**National Committee on
Uniform Traffic Control Devices**

**National Committee on Uniform Traffic Control Devices
TTC TC**

TOPIC: Figure 6H-28 – Typical Application 28 Sidewalk Detour or Diversion

AFFECTED PORTIONS OF MUTCD: Notes for Figure 6H-28, Figure 6H-28

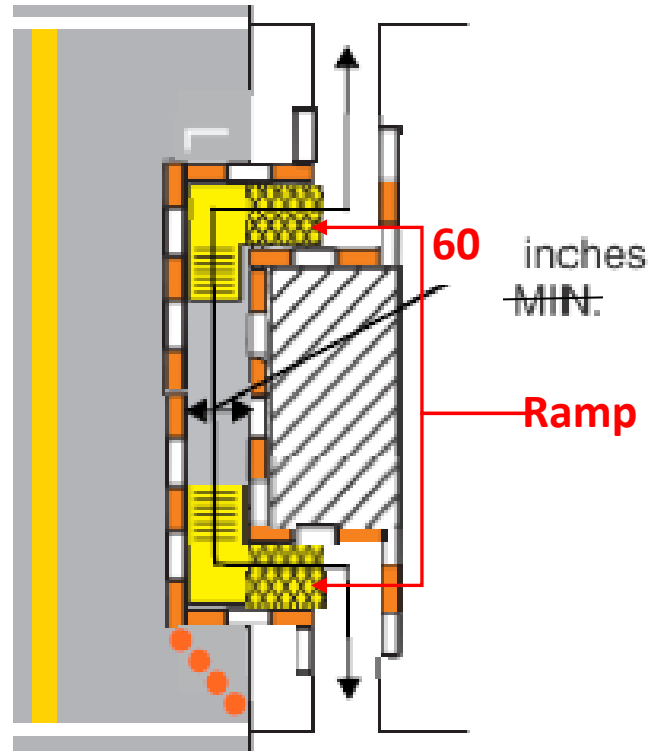
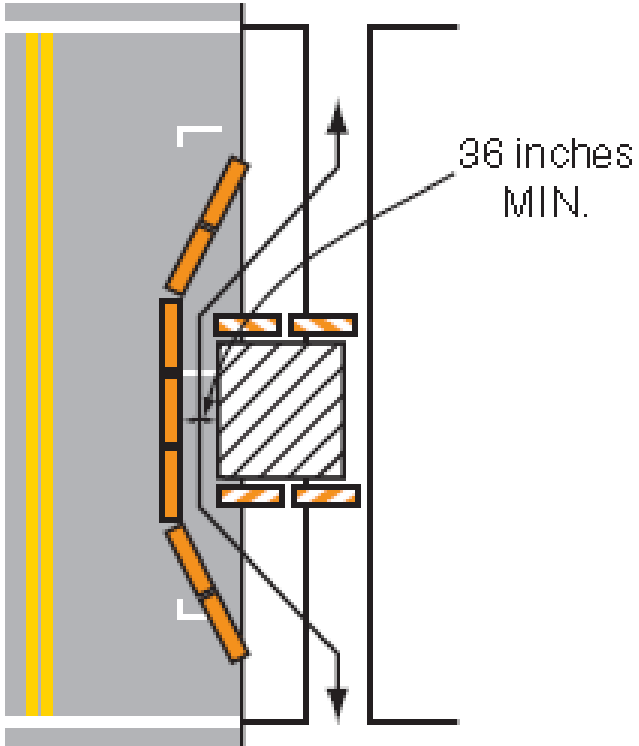
A practitioner recently contacted TTC to note a discrepancy between the Figure for Sidewalk Diversion and other sections in Part 6. Review of the practitioners comment showed several areas where this figure is not compliant with other sections of Part 6. The areas that are not compliant include:

- Lack of an accessible, detectable barricade between the pathway and the work space

- 35 • Use of a type 3 barricade to close the sidewalk which does not provide the detectability that
36 Section 6.
- 37 • Use of the symbol for Longitudinal Channelizing Device to separate the alternate pathway from
38 vehicular traffic without a note requiring that the LDC meet the detectability requirements of
39 Section 6.
- 40 • Width of the alternate pathway is noted at 36 inches while Section 6. Requires 48 inch
41 minimum
- 42 • Lack of notice to practitioners that a ramp is required when elevation changes by more than ½
43 inch.

45
46 Modify Figure 6H-28 Sidewalk Diversion to include longitudinal channelizing devices on both sides of the
47 alternate pathway that are detectable to users of long canes and that have upper and lower rails as
48 noted in 6.; adjust the width to read 48 inches minimum and depict ramps between the curb and the
49 alternate walking surface. Modify the Notes to TA-28 to bring them into compliance with the 2009
50 Edition of the MUTCD and to support the modifications to the Figure. Include in the notes clarification
51 of the use of temporary traffic barriers.

106 Modify the Figure in TA-28 as shown below:

112 [Note – add symbols in 6H-2 for ramp and pedestrian channelizing device]
